Application No. 10/708,928
Amendment dated
After Final Office Action of July 28, 2005

Docket No.: 60680-1780

AMENDMENTS TO THE DRAWINGS

First Named Inventor: Kerry D. Hinson
Title: Fastener Assembly With Wave Spring
Atty. Docket No.: 60680-1780

ANNOTATED SHEET SHOWING CHANGES**FIG. 3****FIG. 4****BEST AVAILABLE COPY**

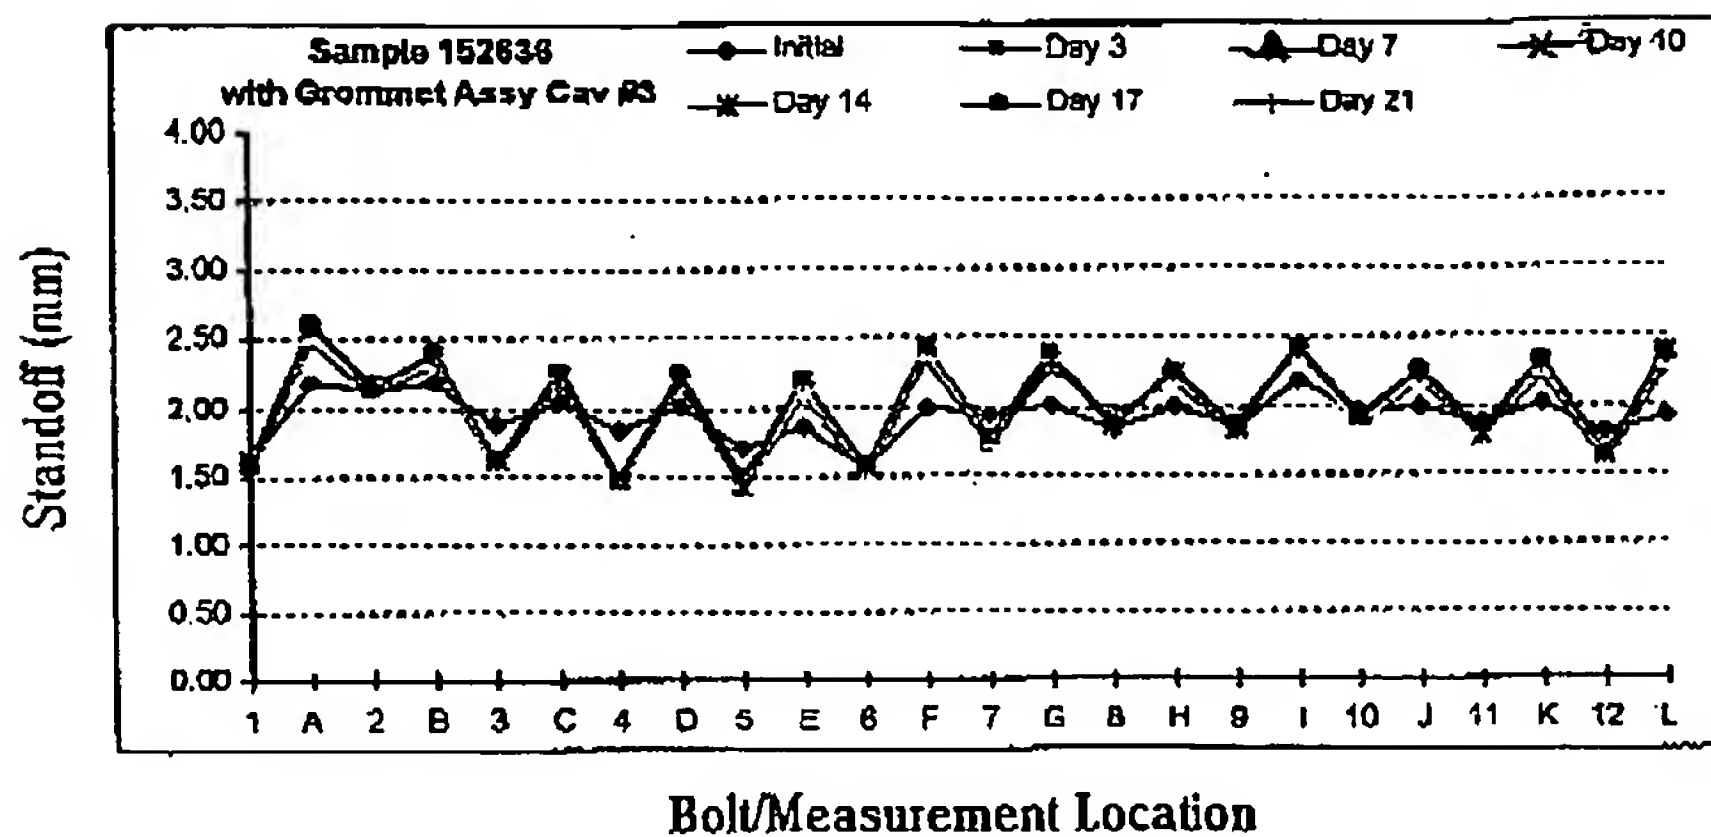
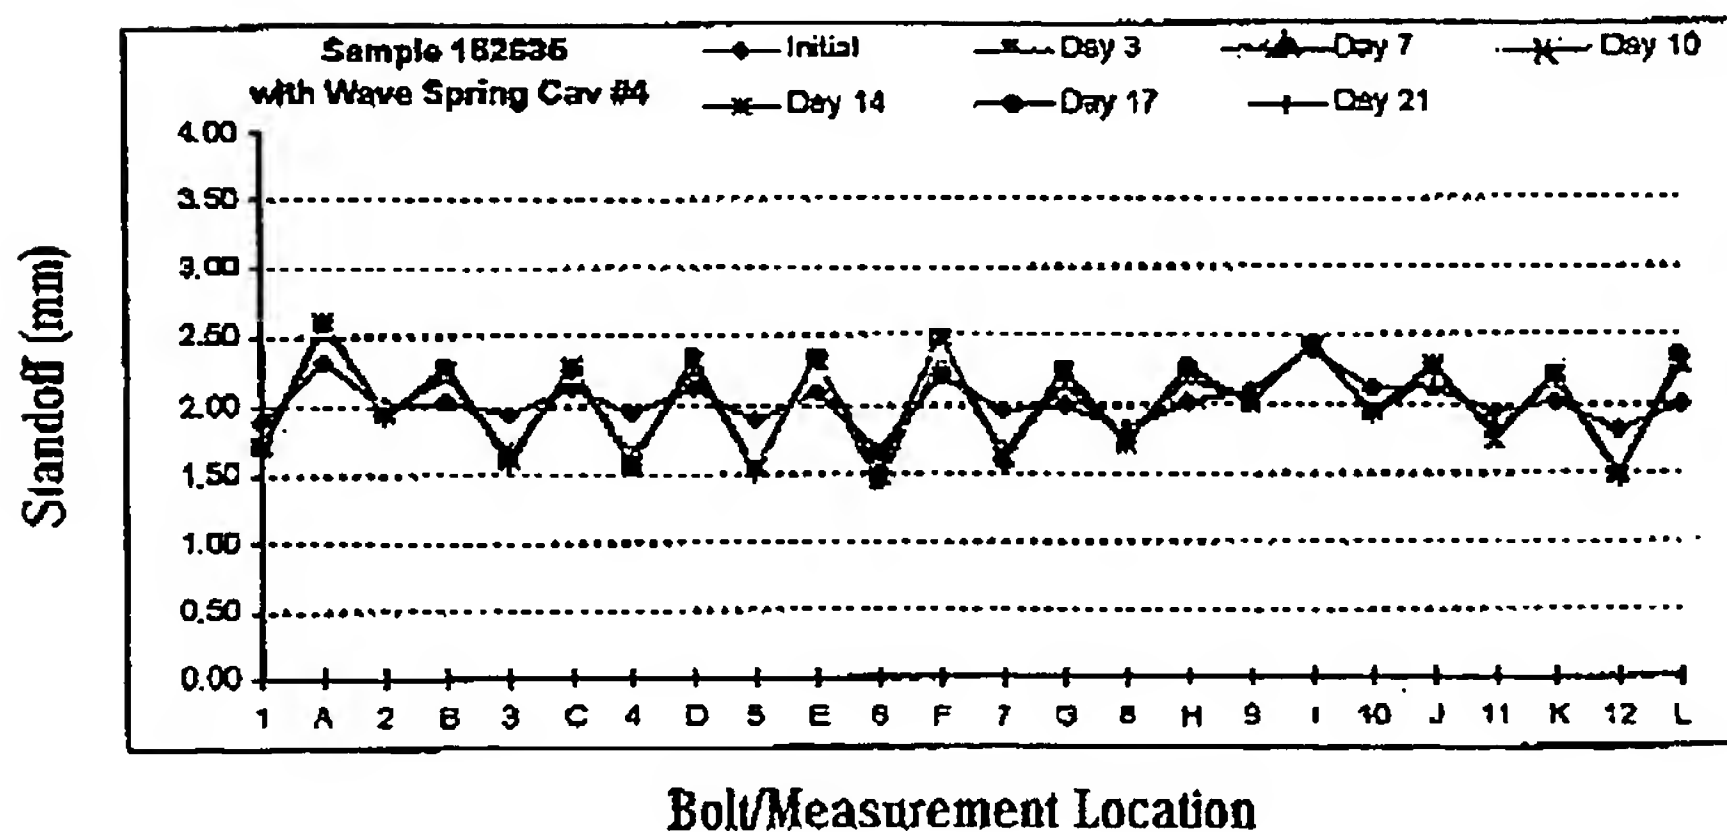
FIGS. 3 and 4 were objected to for not displaying information relating to Day 7 and Day 10, and for illegible data lines. Accordingly, Applicants have amended FIGS. 3 and 4 to clearly identify data lines and information pertaining to "Day 7" and "Day 10".

The attached sheet of drawings includes changes to FIGS. 3 and 4 .
